PSL - PMC

PMC Servo Rev E

Engineering Change Order History		
ECO number	Date	Originator
1	E010166 to Rev C	RK
2	E010223 to Rev C1	RK
3	E010331 to Rev D	RK
4	E010332 to Rev E	RK
5

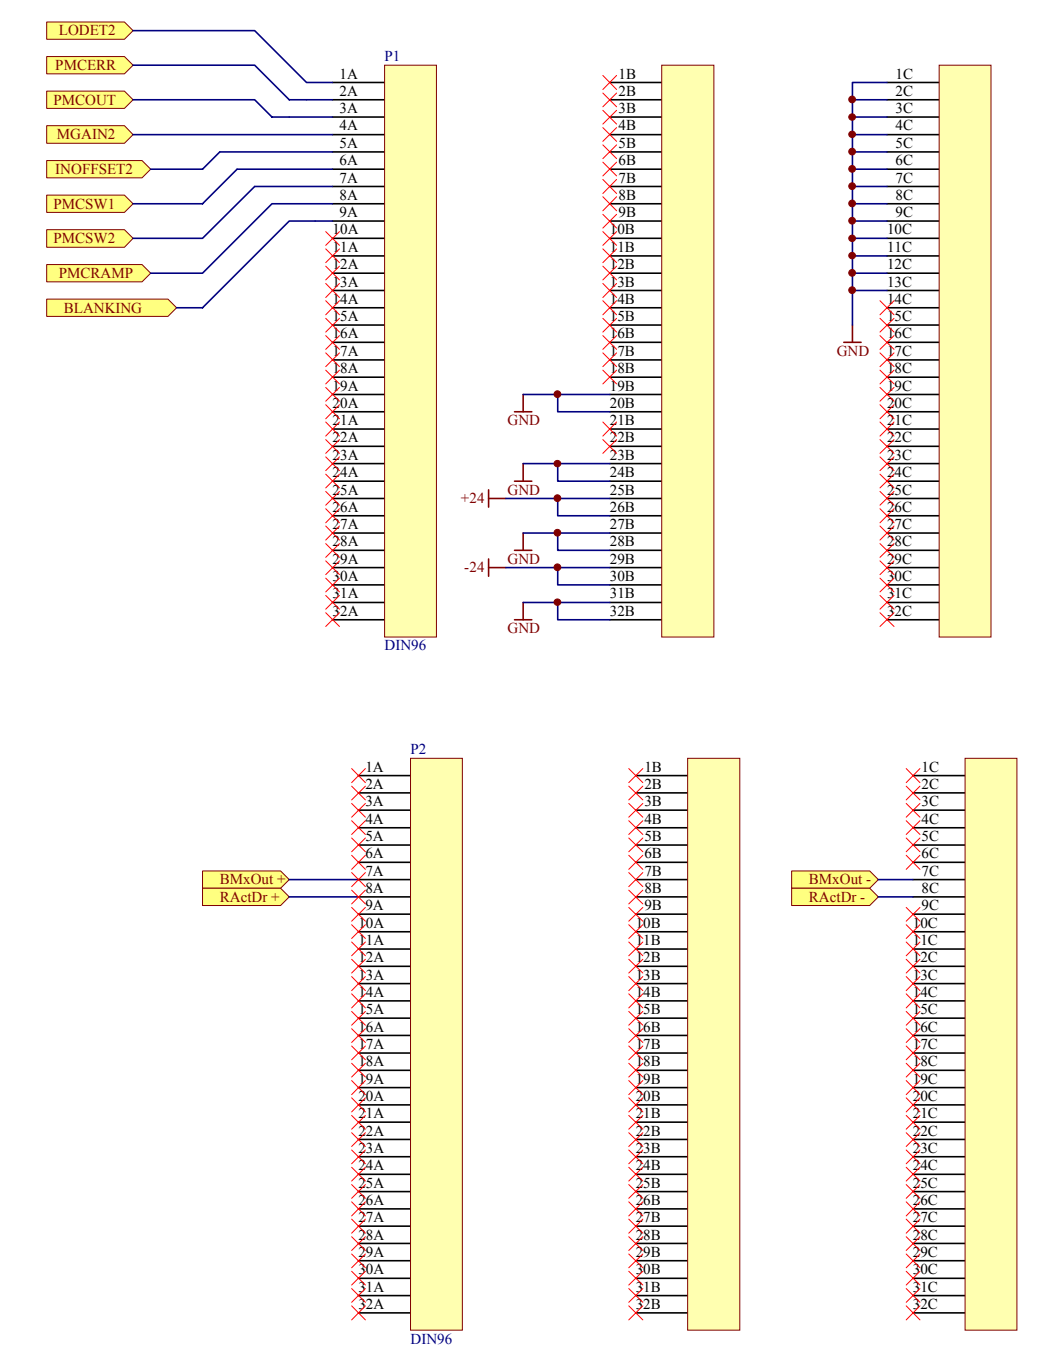
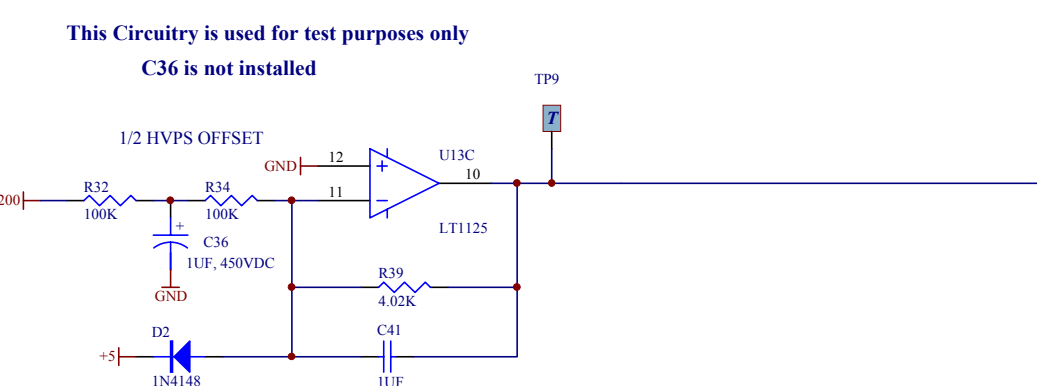
- Schematic Rev D incorporates the following updates**
- * 100 ohm resistors have been added at TP1, TP2, TP4
 - * R43 is formally 332 ohms
 - * Header H1 is in series with R9.
- Schematic Rev E incorporates the following updates**
- * U13-8 and U13-9 are grounded
